## TAKACHI ELECTRONICS ENCLOSURE CO., LTD.

# NOTICE

## Changes to Material and Finish

■ **Affected** : HD series / 6 models

### ■ Details

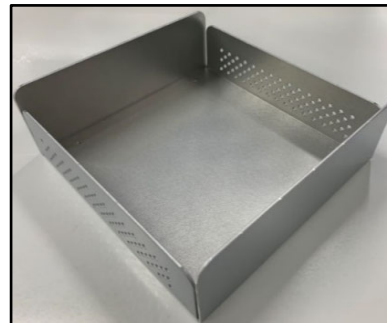
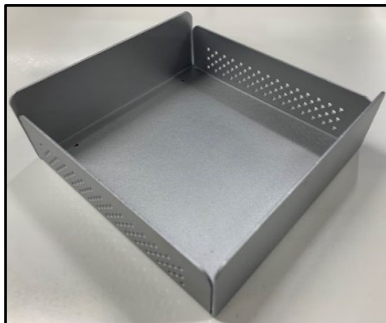
■ **Changes** : Base material and finish ONLY (Cover material and finish is unchanged).

Material	Finish
Aluminium A1050P	Metallic silver / Painted

Material	Finish
Aluminium A1100P	Metallic Silver / Painted Conductive inside

※Conductive inside for EMC shielding.

- **Functionality**: No changes to functionality, size or dimensions.
- **Purpose**: To ensure consistent quality throughout via streamlined supply chain and materials.
- **Period**: Once current inventory has been depleted.
- **Series / Model**: No changes to both Series, and Part numbering.
